CITY OF GARDEN CITY

File Number: DSRFY2019 - 7
For: Riverside Hotel Pool/Fitness Facility
Location: 2900 W. Chinden Blvd. Garden City, Idaho
Applicant: Joshua Hersel, CTA Architects
Design Review Meeting Date: March 18, 2019

STAFF REPORT: DSRFY2019-7

LANDSCAPE PLAN

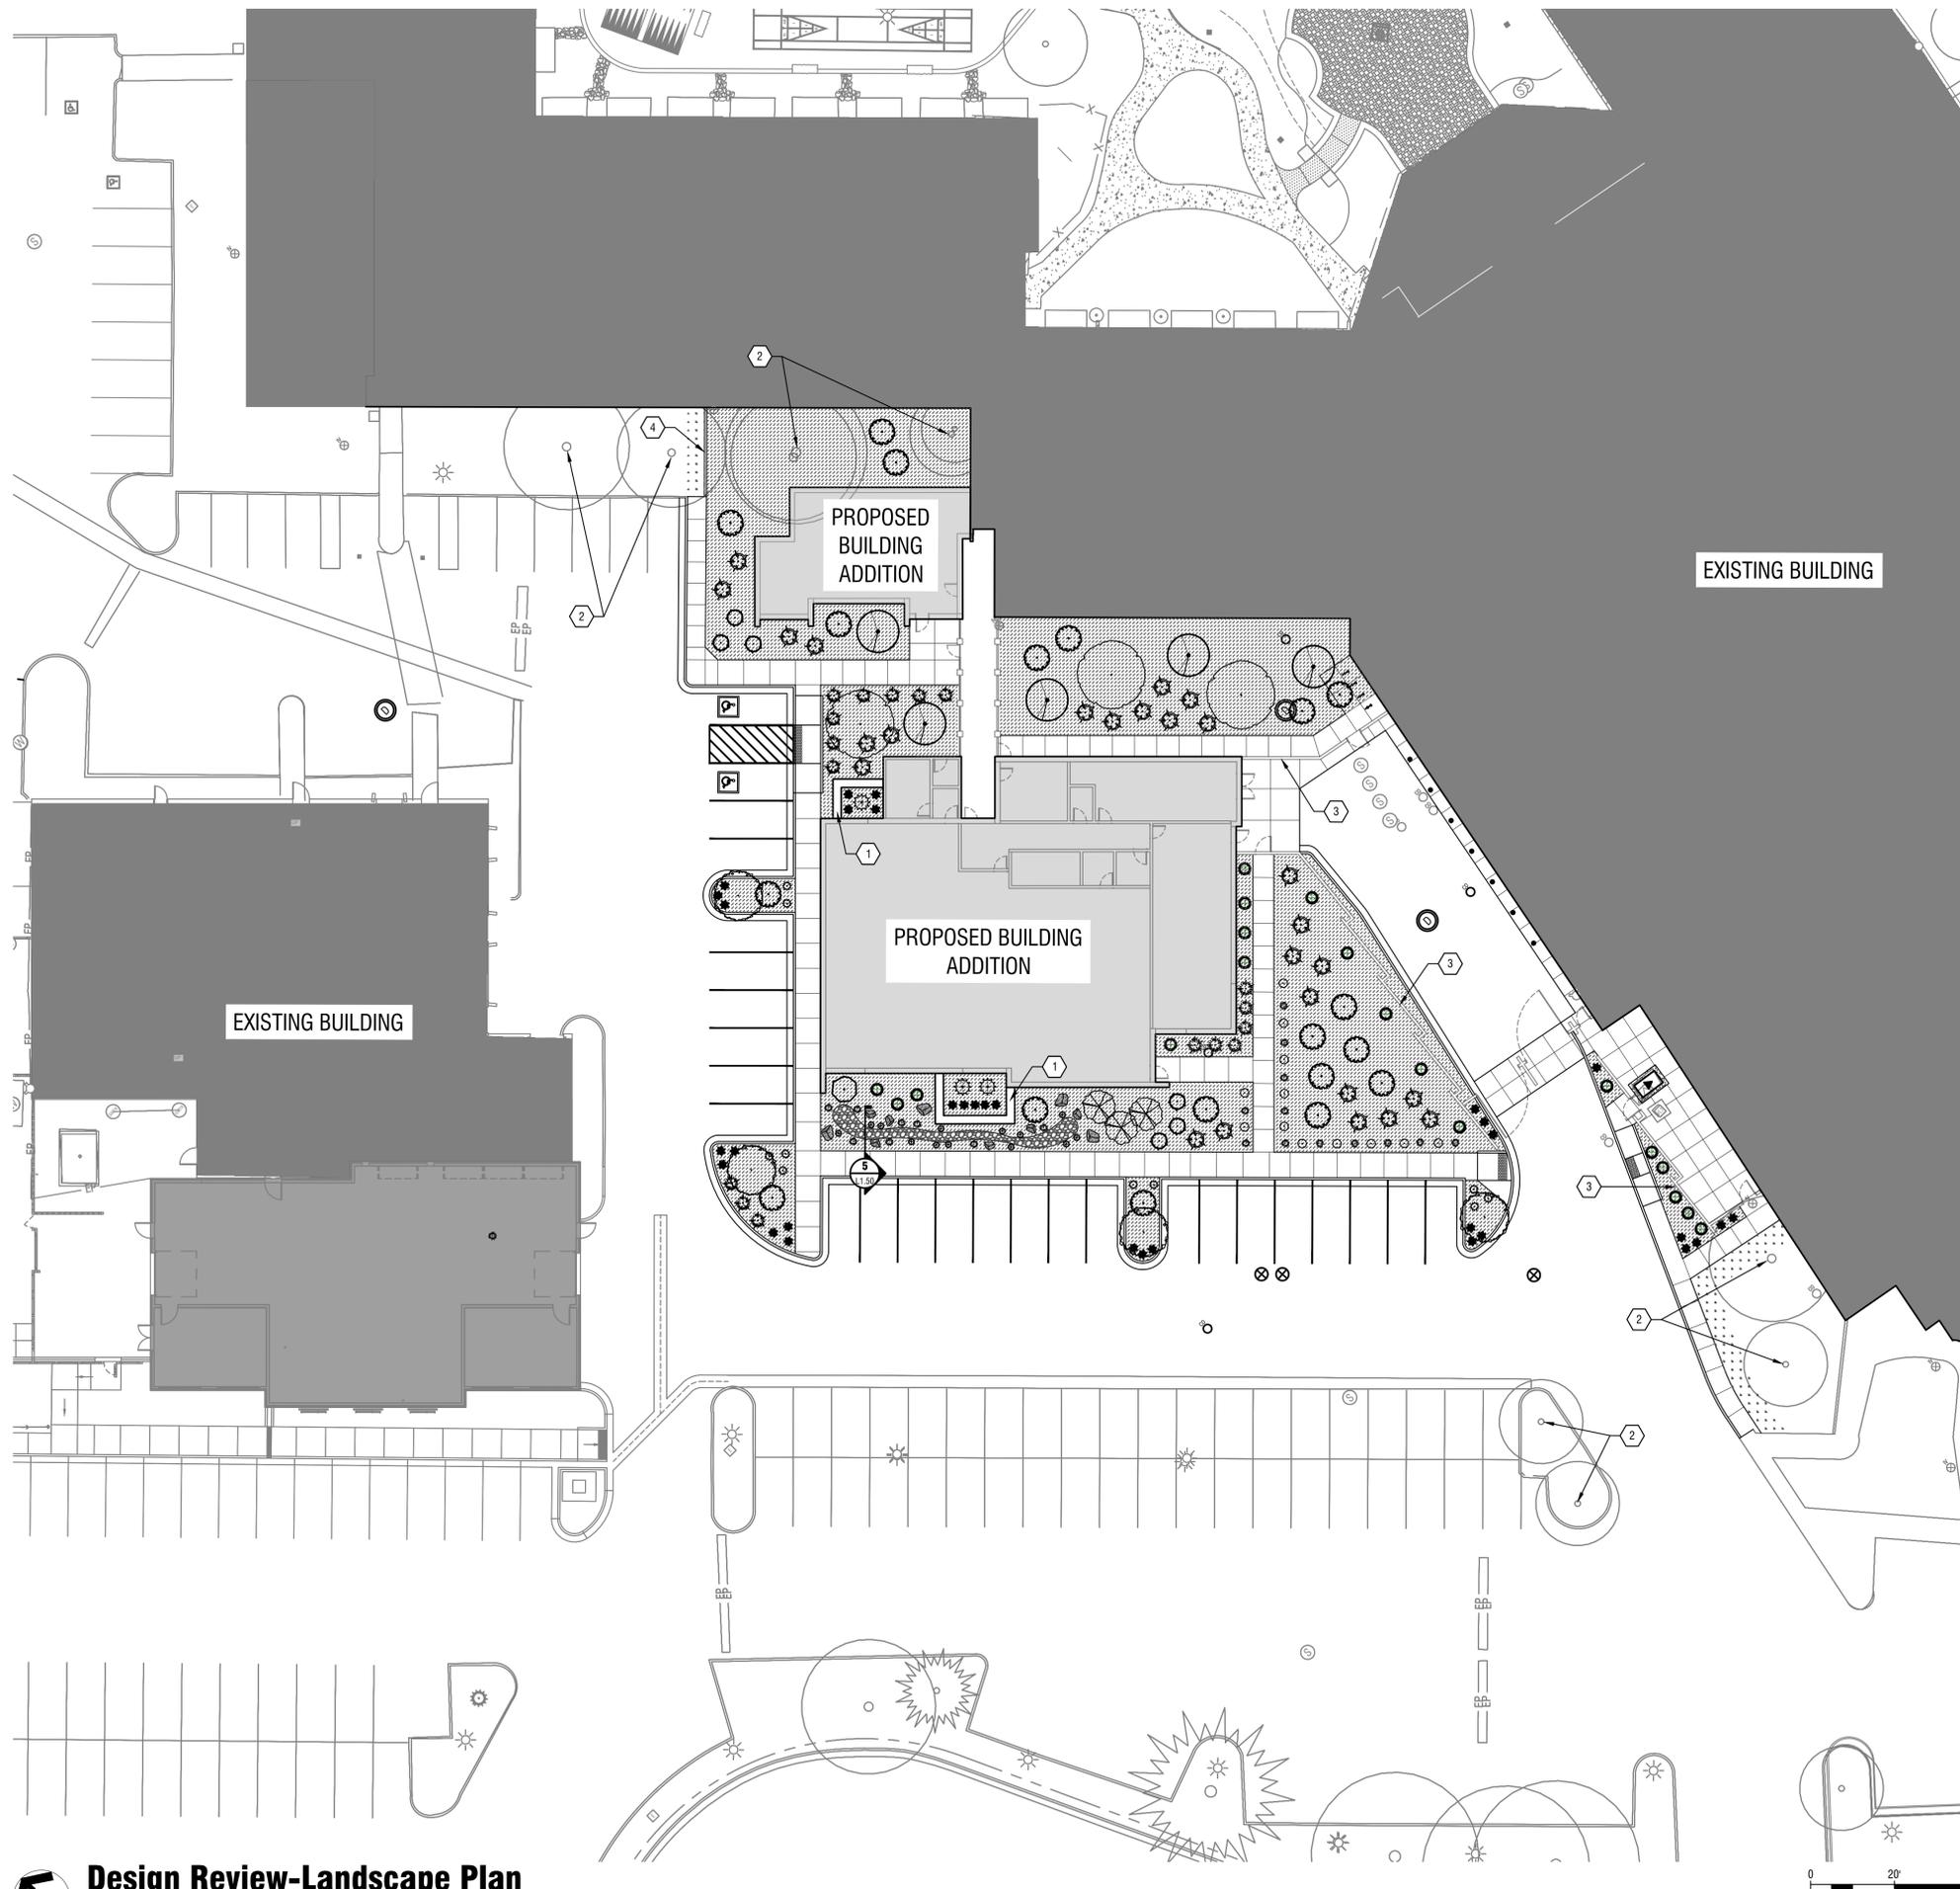
GCC 8-4E-7 Pedestrian and Bicycle Accessibility Standards	The proposed design contains pedestrian connectivity and bicycle parking.
<u>GCC 8-4I Landscaping and Tree Protection Provisions</u>	
GCC 8-4I-3 General Landscaping Standards and Irrigation Provisions	The landscape plan does not provide specific calculations on whether the 70% living material will be met or the impact of rock mulch on this

requirement. However, the plan appears to comply visually.
GCC 8-4I-4(B) Landscaping Provisions for Non-Residential Uses	The landscape plan appears to meet the 5% landscaping requirement, proportional to the proposed design.
GCC 8-4I-5 Perimeter Landscaping Provisions	Perimeter landscaping requirements are not triggered by the proposed design.
GCC 8-4I-6 Parking Lot Landscaping Provisions	Distances from trees to parking spaces are not shown. This information is needed to determine compliance with the 100' maximum distance from trees to parking spaces.
GCC 8-4I-7 Tree Preservation Provisions	The applicant did not provide information on whether any trees would be removed in association with the proposed design.
GCC 8-6A-4(B) Waiver of Required Application Information	The applicant has requested waiver of (LIST WAIVER REQUESTS) OR Not applicable.
	Not applicable. The applicant has not requested a waiver of application requirements.

1 SITE PHOTOMETRICS PLAN
E101 1"=20'-0"

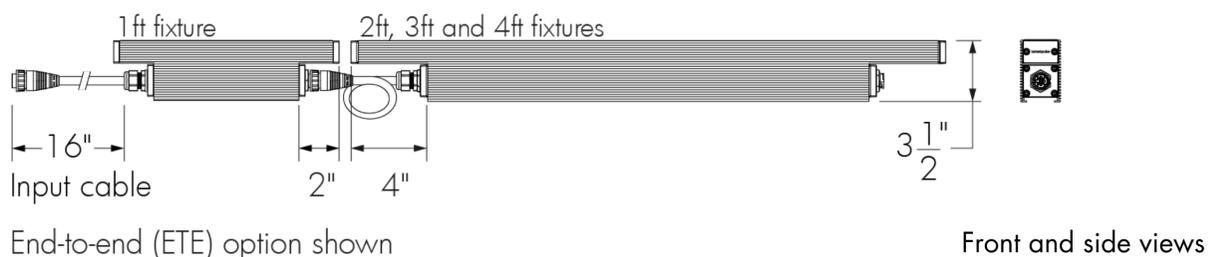
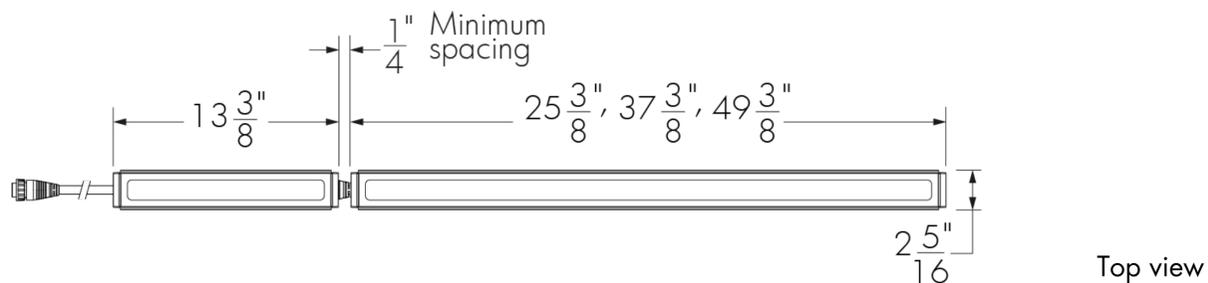
GCC 8-3E-4J Parking	This subsection requires compliance with GCC 8-4D (Parking and Off Street Loading Provisions). Parking requirements will be analyzed below.
GCC 8-3E-4K Prohibitions	The proposal does not appear to contain any listed prohibitions noted in the subsection.
<u>GCC 8-4A Design and Development Regulations – General Provisions</u>	
GCC 8-4A-3 Fences and Walls	Architectural screen walls and a sandstone planter wall have been proposed along the south and east elevations. The proposed walls are not located along property lines.
GCC 8-4A-4 Outdoor Lighting	The applicant has submitted an outdoor lighting plan in accordance with this subsection. Freestanding light fixture height is not known.
